This Service Information bulletin supersedes SI 17 05 12 **dated December 2012.**

Service Action: Retrofit of the Engine Coolant Temperature Sensor

R60 with automatic transmission (N16 or N18 engine)

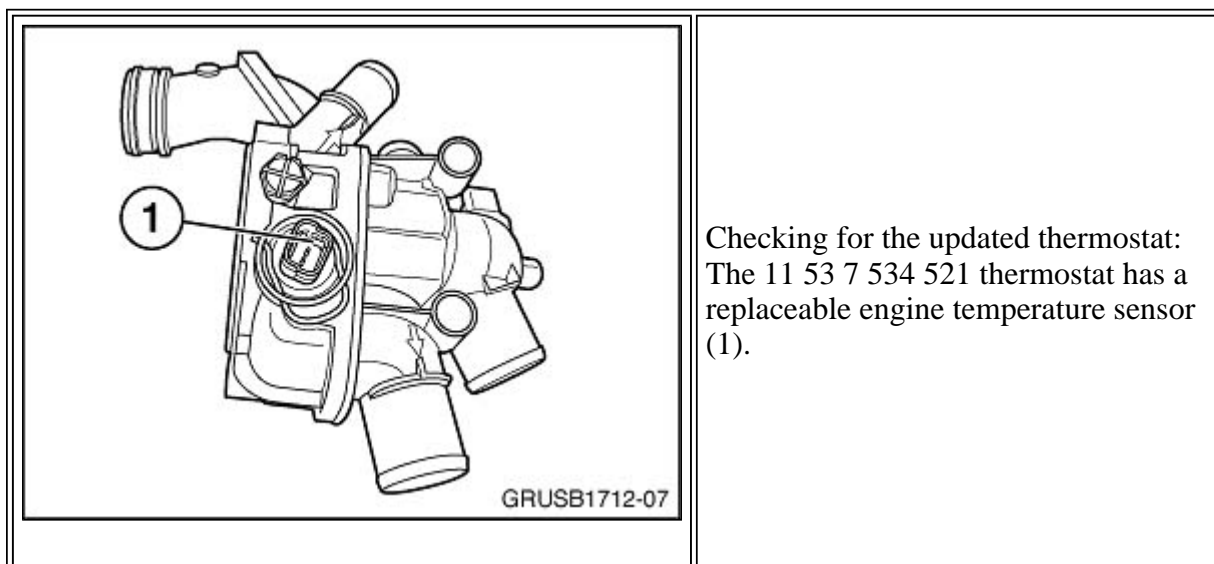
The existing engine temperature sensor will be bypassed electrically, and a new engine temperature sensor will be installed remotely and wired into the vehicle's engine harness. The new engine temperature sensor, with integrated wire harness, will be installed in place of the thermostat bleeder screw.

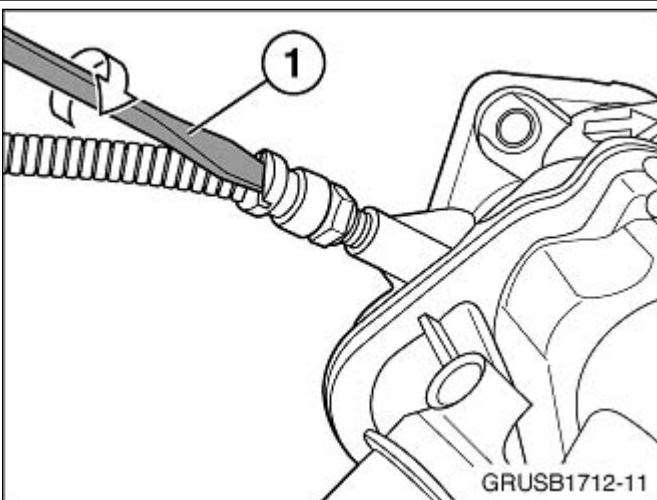
Remove the bleeder screw (1) from the thermostat. This screw will not be reused.

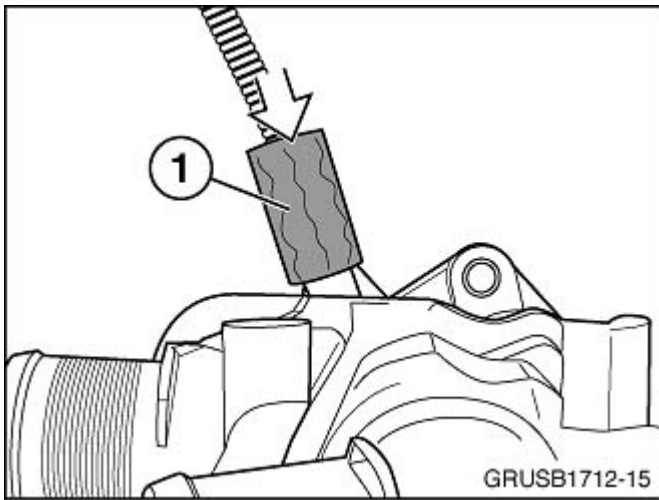
The back of the temperature sensor is slotted to accept a bladed screwdriver (1). Install the sensor into the bleeder screw hole, and torque to 2Nm.

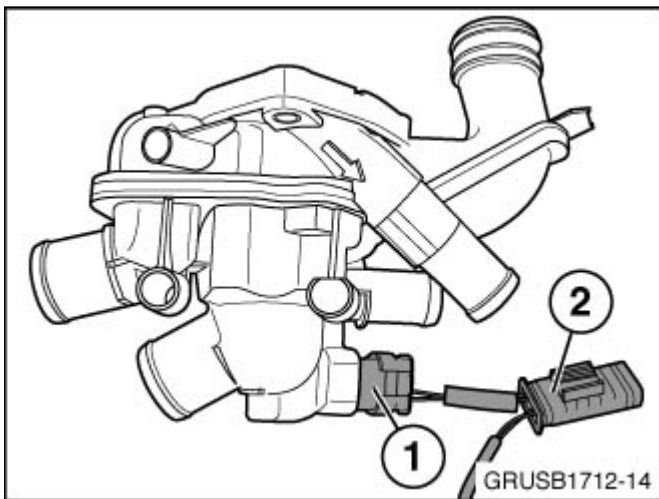
Slide insulating sleeve (1) onto the temperature sensor. The sleeve must completely cover the sensor.

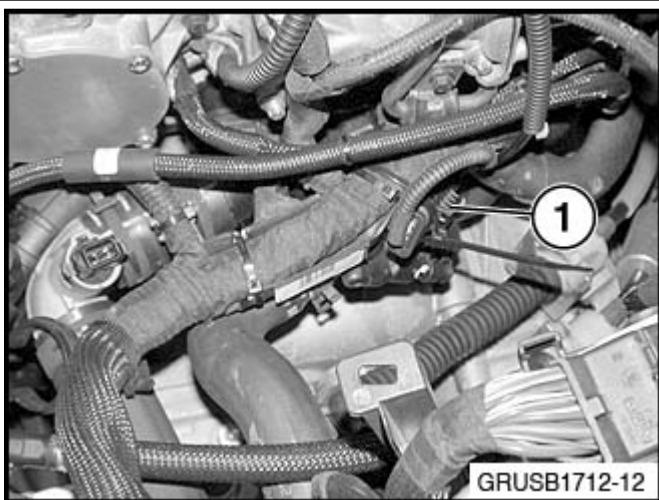
Install the two-pin female connector (1) into the thermostat and the four-pin male connector (2) into the engine wiring harness.

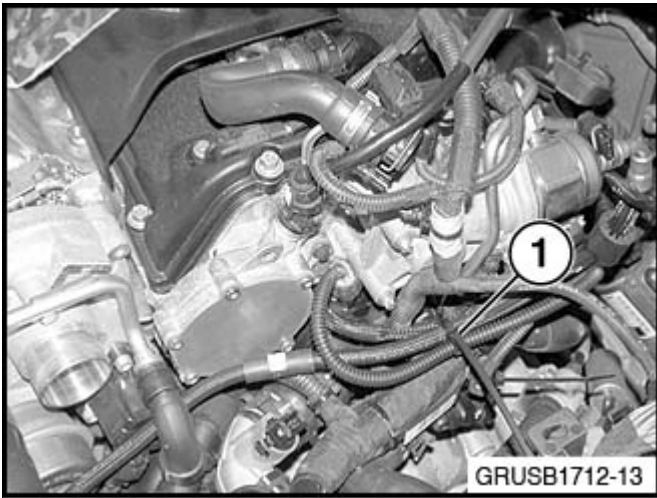
Secure the connector (1) with a cable tie to the engine wiring harness.

Secure the wiring from the temperature sensor (1) with a cable tie.
